UNITED STATES PATENT AND TRADEMARK OFFICE

APPLICATION NO.	FILING DATE	FIRST NAMED INVENTOR	ATTORNEY DOCKET NO.	CONFIRMATION NO.
10/803,178	03/17/2004	Yasunori Kurosawa	81754.0114	4143
26021	7590	10/04/2005	EXAMINER	
HOGAN & HARTSON L.L.P. 500 S. GRAND AVENUE SUITE 1900 LOS ANGELES, CA 90071-2611			DOAN, THERESA T	
			ART UNIT	PAPER NUMBER
			2814

Office Action Summary	Application No. 10/803,178	Applicant(s) KUROSAWA ET AL.	
	Examiner Theresa T. Doan	Art Unit 2814

DETAILED ACTION

FIG. 16

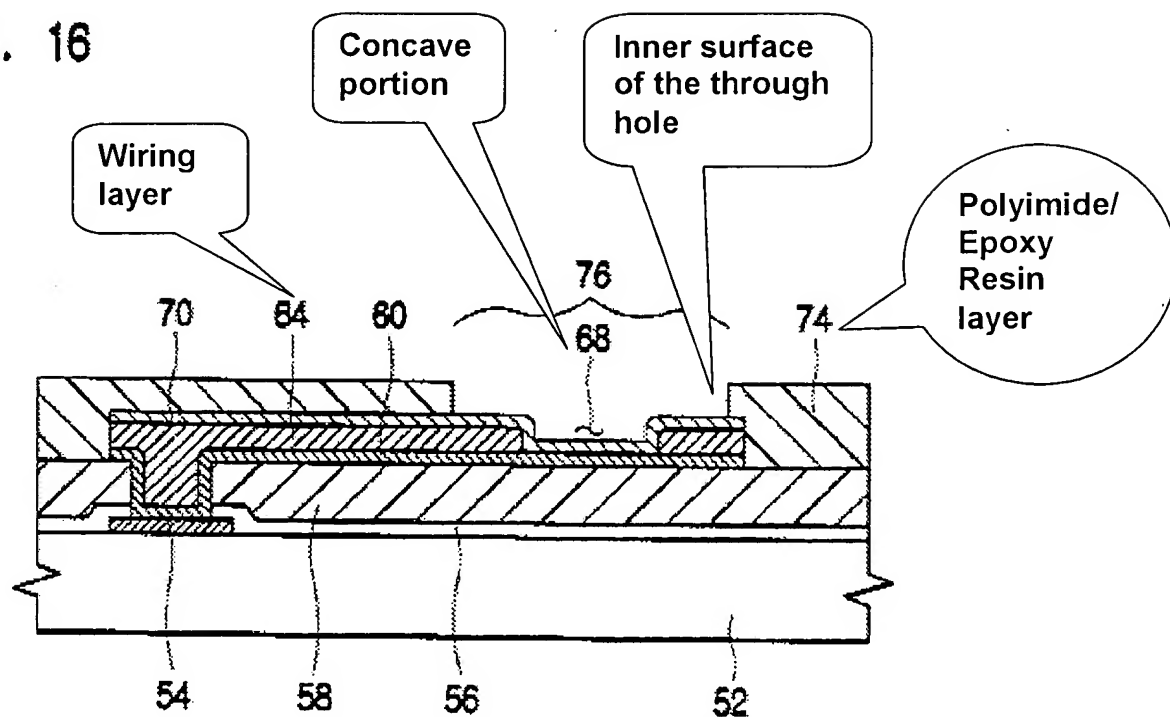
a semiconductor substrate 52 (column 3, lines 55-56) provided with a plurality of integrated circuits (not shown, see column 3, lines 54-56) and pads 54; a semiconductor chip 90 of the semiconductor wafer 50 provided with an integrated circuit (not shown, see column 3, lines 54-56) and a pad 54 (Fig. 17); a wiring layer 64 that has a concave portion 68 (column 4, lines 60-65) and is electrically connected to the pad 54; an external terminal 80 that is joined to the concave portion 68 of the wiring layer 64 (see Figs. 16-17 Labeled by the examiner below and column 5, lines 61-63); and a polyimide or epoxy resin layer 74 (column 5, lines 30-38 and column 3, lines 66-67 through column 4, lines 1-2) provided with a through hole and disposed on the wiring layer 64, the through hole and the concave portion 68 residing at the same position (see Fig. 16 below and column 5, lines 28-30).

FIG. 17

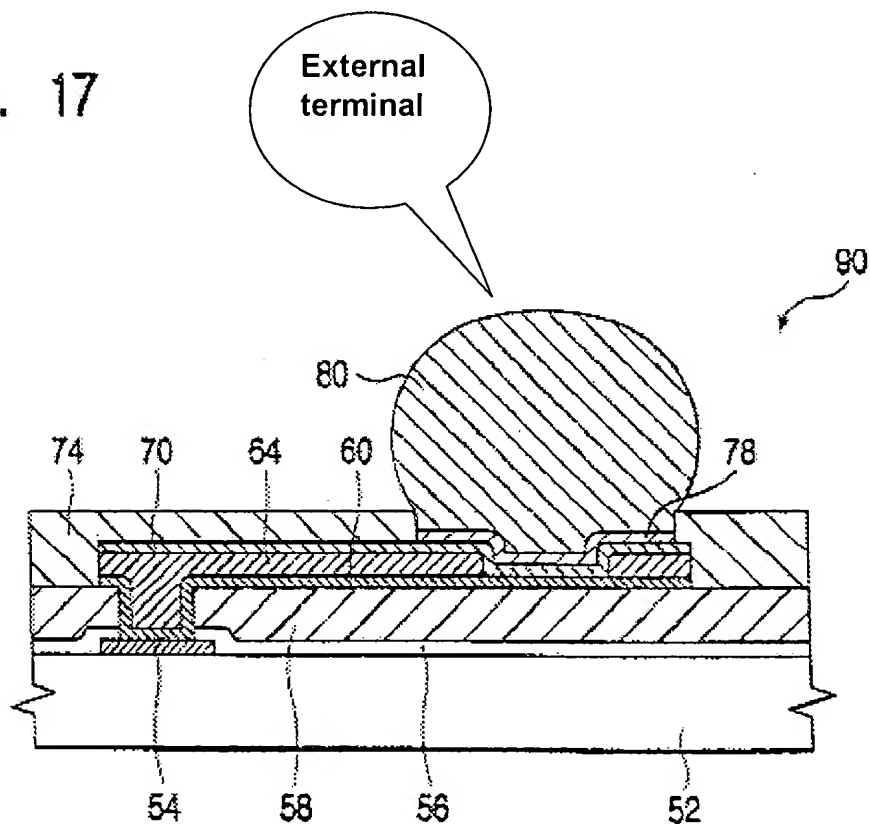
Regarding claims 4 and 12, Hwang discloses that an inner surface of the through hole in the resin layer 74 is in contact with the external terminal 80 (see Fig. 17 Labeled by the examiner above).

Regarding claims 5 and 13, Hwang (Fig. 17) further discloses a stress relaxation layer 58 (column 3, lines 66-67 through column 4, lines 1-2) disposed on the semiconductor chip 50, wherein the wiring layer 64 is disposed on the stress relaxation layer 58.
